New CAT approved for IP66M– New configurators

We are happy to announce that on April 30, 2020, the Ewellix factory in Gothenburg will launch a new motor house design for the CAT series. The change will only affect the standard range options as found in our catalogue and the ones with CxxC motors.

Enclosure showing dimensions that will change with new design. Other dimensions will remain as before.

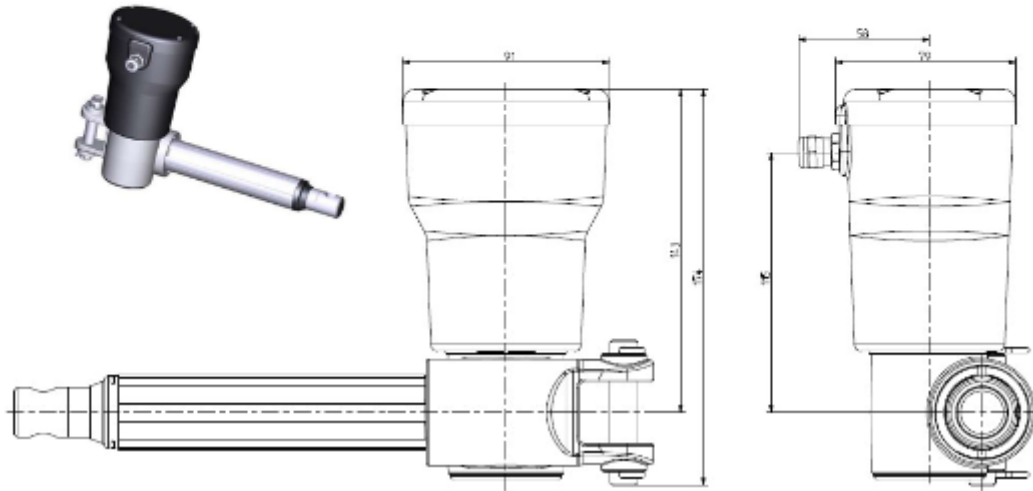
- EMC filter will always be mounted in the actuator to comply with the EMC directive EN 61000-6-3 Group 1 Class A (Light industry and household)
- Dimensions of motor housing will be changed to accommodate EMC filter (See drawing)
- IP 66 will be the standard execution
- Cable will be the standard supply

1. New design

2. Current design
